Interactive comment on “CABra: a novel large-sample dataset for Brazilian catchments” by André Almagro et al.

Response to Referee #1 - Pedro Luiz Borges Chaffe

Fig. 1. Figure R1. Scatter plots and correlation coefficients between hydrological signatures of CABra and CAMELS-BR catchments. There was 607 catchments and 13 hydrological signatures overlapped.

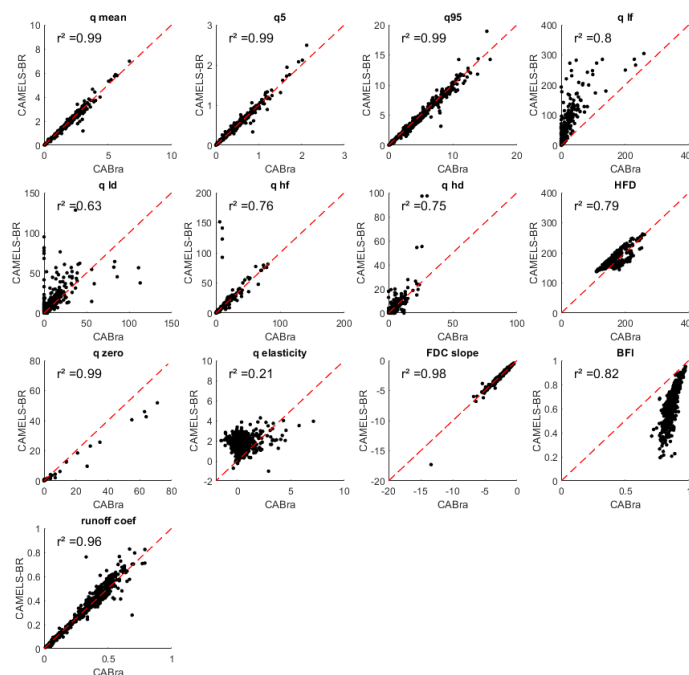
Comment #2: As major comments, I believe the authors could highlight those new products they produced and the novelty of the manuscript by: (1) framing CABra as a complementary dataset that builds on some opportunities left by the CAMELS-BR dataset (e.g., need for drainage density and uncertainty analysis); (2) making use of the CAMELS-BR for a quantitative comparison to show if or how the different approaches and data sources might influence signature values. I would also create a new section after the Introduction called “2 Motivation to extend the CAMELS-BR data set” similarly to Addor et al. (2017). This new section would be a more concise and accurate (see minor comments) replacement of section “3 Comparison with the CAMELS-BR. . .” of the current manuscript.

have performed (see Fig. R1) a simple but effective analysis to verify in which hydrological signatures and how the different approaches may impact more. We performed a correlation test in 607 corresponding catchments in both datasets. As can be seen in the figure, the signatures based only in daily streamflow values, such as daily mean streamflow (q_{mean}), 5th and 95th quantiles of daily streamflow (q_5 and q_{95}), are quite similar between CABra and CAMELS-BR, showing that both periods of analysis were capable to capture the streamflow patterns of the catchments. When comparing signatures related to frequency and duration of low and high streamflow events, we can note little variation but still good agreement between datasets. In this case, the distinct period for hydrological signatures calculation (1980-2010 in CABra, and 1990-2009 in CAMELS-BR) might be the cause of deviations. The slope of flow duration curve and runoff coefficient are in a very good agreement ($r^2 > 0.95$), demonstrating that both datasets are using precipitation products with good reliability. The streamflow elasticity and baseflow index have presented notable differences between CABra and CAMELS-BR. This might be due to the different components adopted in the equations of Woods (2009) and Ladson et al. (2013), which were implemented for elasticity and baseflow index calculations. This discussion can be found at L687-701 of the track change revised manuscript. (3) We are thankful for the suggestion, but we disagree with referee's comment. The section "2 Motivation to extend the Newman et al. (2015) data set" of Addor et al. (2017) is in a completely different context. The CAMELS-US dataset is really an extension of the Newman et al. (2015) dataset, which provides daily meteorological forcing (from three different sources) and daily streamflow (from USGS) for 671 catchments in US. From these 671 catchments previously defined by Newman et al. (2015), a wide range of geophysical attributes were made available Addor et al. (2017). To derive the climatic indices, authors also used the Newman et al. (2015) daily meteorological timeseries. To derive the hydrological signatures, authors also used the Newman et al. (2015) daily streamflow timeseries. Summing up, the dataset provided in Newman et al. (2015) was taken as a basis for the development of CAMELS-US, and more than that, it is part of CAMELS-US. In turn, the

Fig. 2. Figure R2. Location of the 132 corrected outlets.

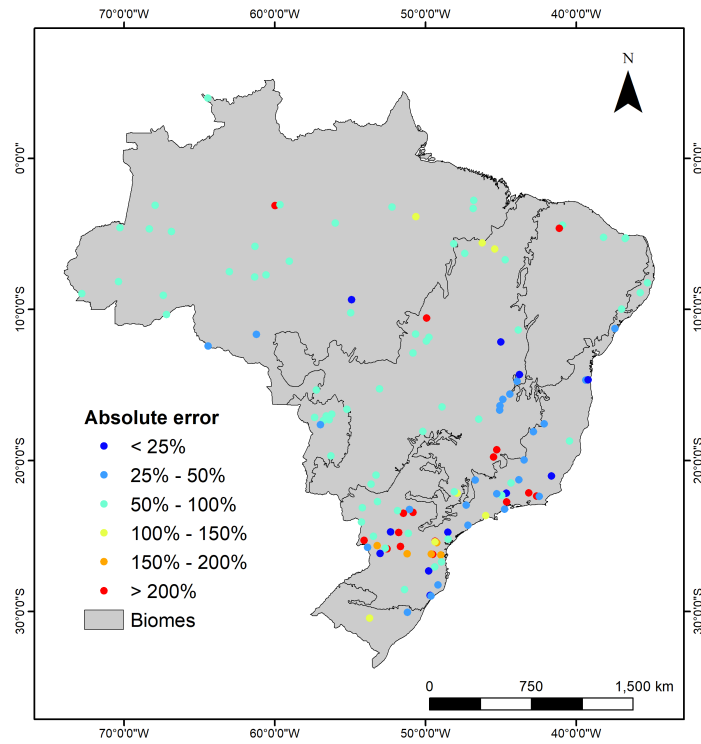
Comment #9: L115 – Can you specify somewhere what are the 132 catchments?

Author's response #9: Sure. The location map of the 132 mentioned catchments is attached in Figure R2.

Fig. 3. Figure R3. Budyko space applied for data from REF, ERA5 and ENS climate datasets.

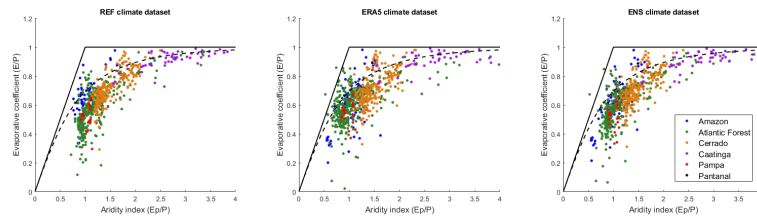
Comment #12: L165-172 – I think this ensemble can be another nice product of your data set if better described. Do you think that an ensemble mean product is always "more reliable"? Could you compare and show the differences?

Author's response #12: Thanks for the comment and suggestion. We have improved the presentation of the ensemble product in the revised version of the manuscript (see L171-175 of track change revised manuscript). We believe that it is not appropriate to say that an ensemble is always better than individual products, but it is a fact that an ensemble will avoid unrealistic values generated by individual products and are an

important tool to overcome spatial lack of stations in ground-based products, such as Xavier et al. (2016) dataset used in CABra. Newman et al. (2015b) found that ensemble product of precipitation and temperature still capture the main features of the variables and, moreover, improves the identification of extreme event frequency. When talking about climate projections, it is known that an ensemble generally outperforms individual forecasts (Bellucci et al., 2015; Solman et al., 2013; Tebaldi et al., 2005), being capable to detect internal variability and seasonal patterns. In CABra dataset, the main goal of creating such ensemble was to create a product covering all the catchments extension, merging two high-resolution and high-quality products that englobes all desired climate variables. The plot of the catchments in the Budyko space can be seen in the attached Figure R3, for REF, ERA5, and ENS climate datasets, respectively. We can note that the main climate features are captured by all the datasets, with catchments in Caatinga being more arid, followed by the Cerrado. The Atlantic Forest is in the same location at the Budyko space, while some catchments in Amazon only appears on ERA5 and ENS dataset, due to its extension outside REF.

Fig. 4. Figure R4. Hydrological signatures importance for hydrological disturbance index by a random forest regressor algorithm.

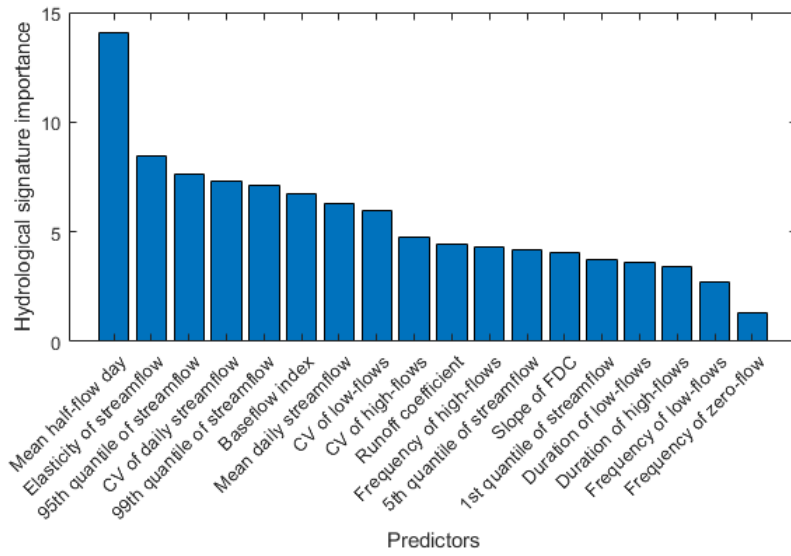
Comment #34: L545-551 – While the Hydrologic Disturbance index is an interesting and novel product, you do not explain how you determined those coefficients in Eq.6. You should investigate how to evaluate the usefulness of the index against the hydrologic signatures that you calculated. What does it capture? Can we use it to somehow classify what you observed?

Author's response #34: Thanks for the comment and suggestion. Our goal was to create a simple index, with easily accessible inputs, that is capable to measure how much disturbed a catchment is in relation to its hydrology. Since the beginning of CABra development, it was known that most of the catchments were minimally urbanised, but with some of them with changes in the original land-cover (conversion of natural vegetation to cropland/pasture). Some studies conducted in Brazil found that, besides the fact of the interference by the conversion of natural vegetation to pasture, this led to minimal changes in the surface hydrology of the catchment, being more relevant to groundwater recharge and soil chemistry (Bacellar, 2005; Lanza, 2015; Nepstad et al., 1994; Salemi et al., 2012). Additionally, it has been seen that the human-induced impact of the reservoirs can be more relevant than the natural ones, and can significantly alter natural hydrological processes (Zhao et al., 2016), leading to an increase/decrease of streamflow and hydrological droughts characteristics (Wanders and Wada, 2015; Ye et al., 2003; Zhang et al., 2015). Moreover, Zhang et al. (2015) found that hydrologic vulnerability is also directly related to human water abstractions, but this can be compensated by streamflow regulation of the reservoirs. This led us to an integrated analysis of the reservoir regulation and human water abstract to reach the optimal balance on our index. Based on the abovementioned, we have decided to use weighted information about the land-cover, reservoirs, and water demand of each catchment. We considered the reservoir-based information with more impact: regulation capacity with 40%, number of reservoirs and its percentage of catchment area with

5% each. The second most impacting factor of the index is the non-natural land-cover in the catchment, which can lead to modify hydrological surface and subsurface processes, with 40% of the weights. Finally, the water abstraction of the catchment was pondered with 10%. We applied a random forest algorithm for a regression analysis (see the attached Figure R4) that showed us the most relevant hydrological signatures captured by the Hydrologic Disturbance Index. About 25% of the variance of the HDI is explained by the Half-flow day and the Streamflow Elasticity, which are two signatures extremely sensitive to streamflow regulation. Our results show us that the index is capable to capture what it was intended to: catchments with higher values presents a large number or high regulation capacity of reservoirs, or a great percentage of non-natural areas. Medium values present some level of non-natural areas (pasture or crops), but there is not a high hydrological disturbance. Finally, lower values of HDI indicates minimally human-impacted catchments.
